HISTORIC AND DESIGN REVIEW COMMISSION

HDRC CASE NO: 2021-523
ADDRESS: 221 NEWELL
LEGAL DESCRIPTION: NCB 959 BLK LOT 25 THRU 32, S IRR PT OF LOT 33 THRU 39 & 40
ZONING: IDZ, RIO-2
CITY COUNCIL DIST.: 1
APPLICANT: Thomas Brown/Clayton Korte
OWNER: RIO PERLA PROPERTIES LP
TYPE OF WORK: Exterior alterations, fenestration modifications, terrace installation, storefront system installation, repair and maintenance, site and paving modifications
APPLICATION RECEIVED: October 01, 2021
60-DAY REVIEW: Not applicable due to City Council Emergency Orders
CASE MANAGER: Edward Hall

The Samuel's Glass Building, 221 Newell Avenue, San Antonio, Texas 78215

4 NEWELL DEMOLITION ELEVATION - SOUTH
1/16" = 1'-0"

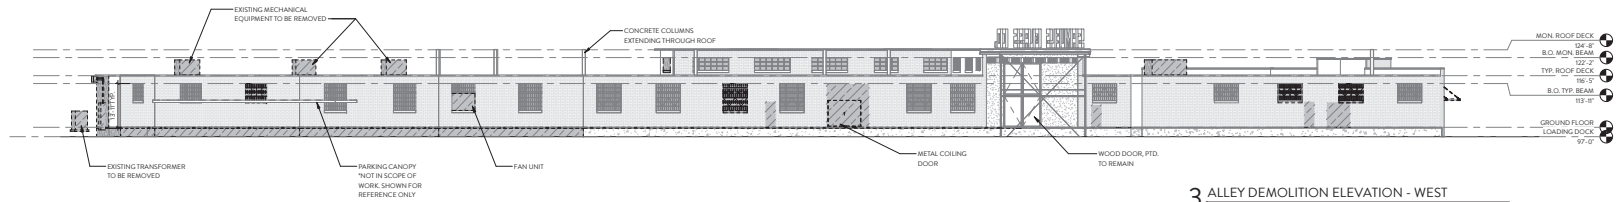
- c. **FAÇADE MODIFICATIONS (South, Newell Façade)** – The applicant has proposed to perform façade modifications to the south (Newell) façade by expanding the existing loading dock, replacing the existing overhead rolling doors, low wall and steel windows with new overhead doors and a new aluminum storefront system, and create a larger entry vestibule. The Guidelines for Exterior Maintenance and Alterations 10.B.i. notes that new façade elements that alter or destroy the historic building character of a structure should not be introduced. Generally, staff finds that the proposed modifications are consistent with Guidelines as they maintain the industrial nature of the structure. Additionally, staff finds that all removed façade materials shall be salvaged for reuse.

2. Staff recommends approval of item #2, façade modifications to the south façade based on finding c with the following stipulations:
 - i. That all removed façade materials shall be salvaged for reuse.

- ii. That detailed product specifications for the proposed storefront system are submitted to OHP staff for review and approval.
3. Staff recommends approval of item #3, façade modifications to the east façade based on finding d with the following stipulations:

3 ALLEY DEMOLITION ELEVATION - WEST
1/16" = 1'-0"

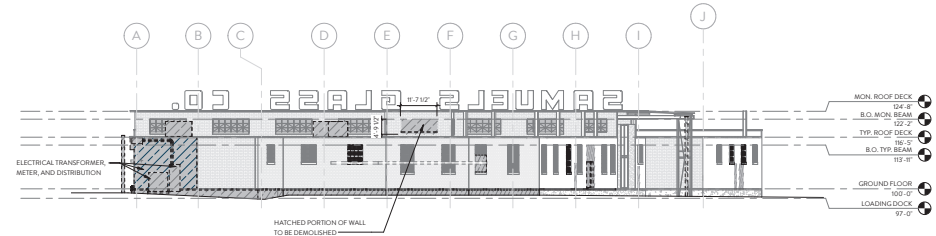
- f. **FAÇADE MODIFICATIONS (West, Alley Façade)** – The applicant has proposed to perform façade modifications to the west, alley façade by adding a patio terrace with breeze block guardrails, screen walls, and service ramp. Staff finds the proposed modifications to be appropriate as existing architectural features will be minimally impacted. Staff finds that any removed façade materials shall be salvaged for reuse.

- i. That all removed façade materials shall be salvaged for reuse.
6. Staff recommends approval of item #6, street scape modifications to Karnes Street with the following stipulation:

1 KARNES DEMOLITION ELEVATION - EAST
1/16" = 1'-0"

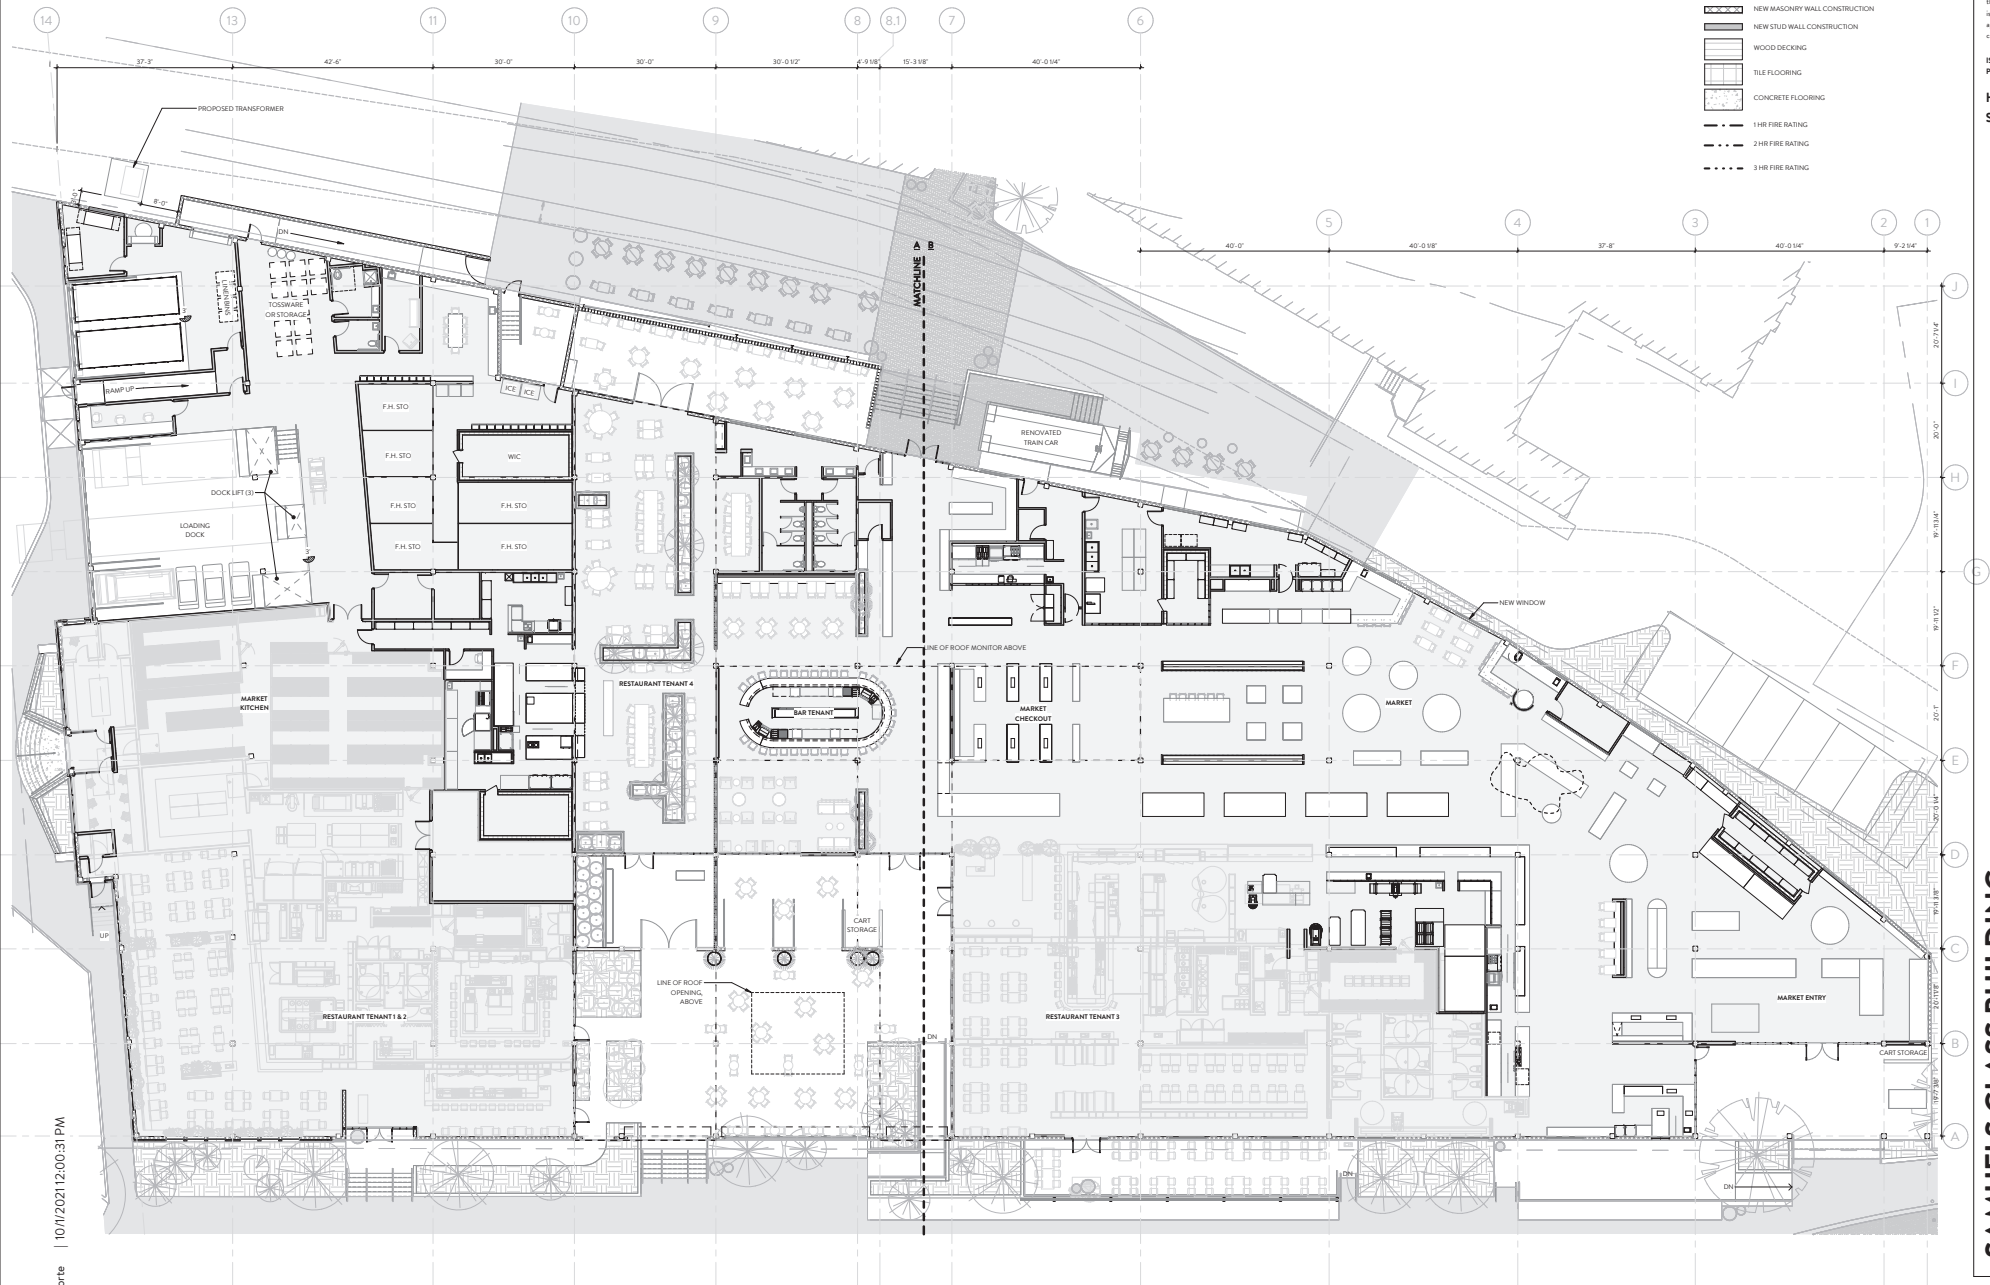
- d. **FAÇADE MODIFICATIONS (East, Karnes Façade)** – The applicant has proposed to perform façade modifications to the east (Karnes) façade by creating several new entrances, replace an existing window with a new entry into a raised dining terrace, the installation of various raised terraces and a new canopied terrace. The existing east façade features three overhead rolling doors and industrially sized steel windows. The Guidelines for Exterior Maintenance and Alterations 10.B.i. notes that new façade elements that alter or destroy the historic building character of a structure should not be introduced. Staff finds the proposed modifications to the east façade generally maintain the existing profile and form of the original façade, while incorporating new elements. Staff finds the proposed modifications to be appropriate and consistent with the Guidelines. Additionally, staff finds that all removed façade materials shall be salvaged for reuse.

- i. That all removed façade materials shall be salvaged for reuse.
 - ii. That detailed product specifications for the proposed storefront system are submitted to OHP staff for review and approval.
